UNITED STATES PATENT AND TRADEMARK OFFICE

Office Action Summary	Application No. 10/723,569	Applicant(s) BEIGANG, WOLFGANG	
	Examiner Lan Nguyen	Art Unit 3683

DETAILED ACTION

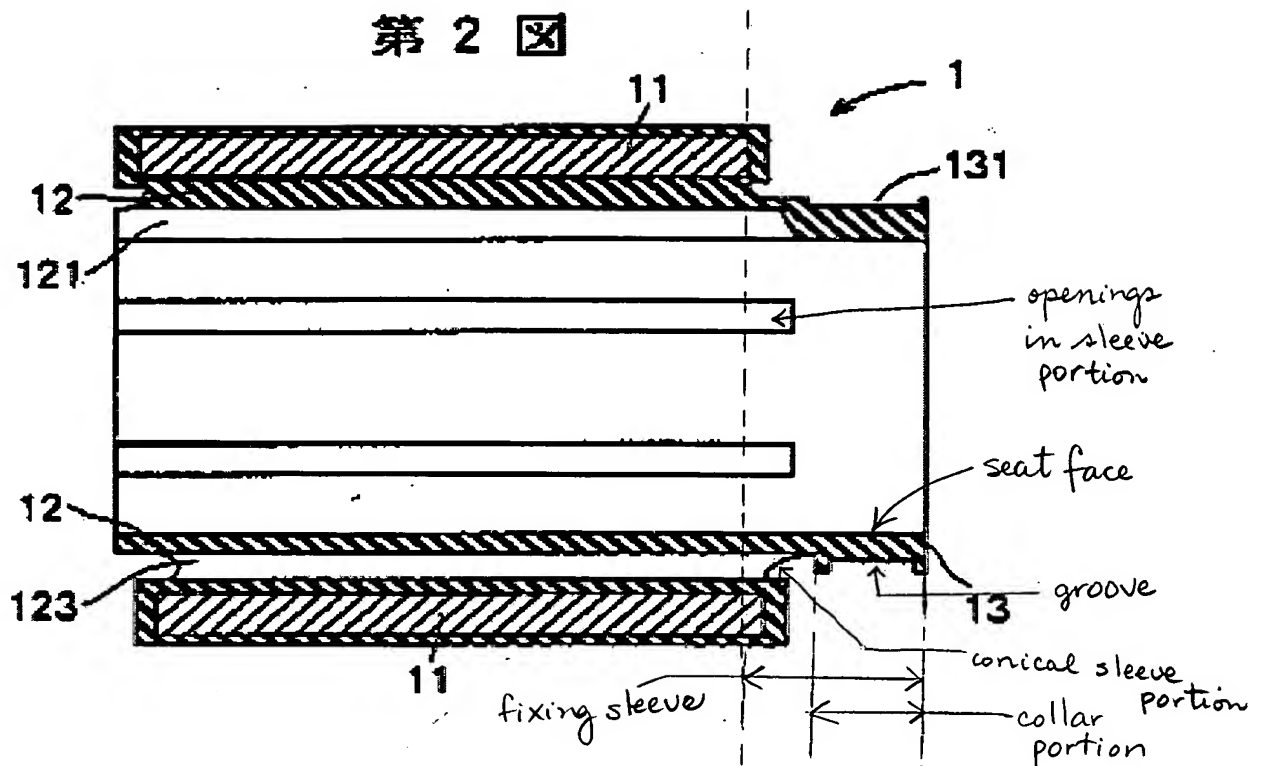
Re: claim 1, Hamada shows in figures 1 and 2, a vibration absorber for attaching to a rotatable driveshaft, as in the present invention, comprising: an annular-cylindrical mass member 11 arranged at a radial distance from the driveshaft; a plurality of circumferentially spaced elastic supporting elements 12 shaped to be positioned on the driveshaft, which are firmly connected to the mass member 11 and extending radially inwardly toward the driveshaft from the mass member; and an elastic fixing sleeve shaped to be positioned on the driveshaft and at one end connected to the mass member 11 (see below marked up figure 2).

Re: claim 2, please see above for the sleeve portion.

Re: claim 3, please see above for the collar portion and seat face.

Re: claims 9 and 10, please see above for the marked up sleeve portion.

Re: claim 13, please see above for marked up groove to receive clamp band.

Re: claim 21, please see marked up openings in sleeve portion above.
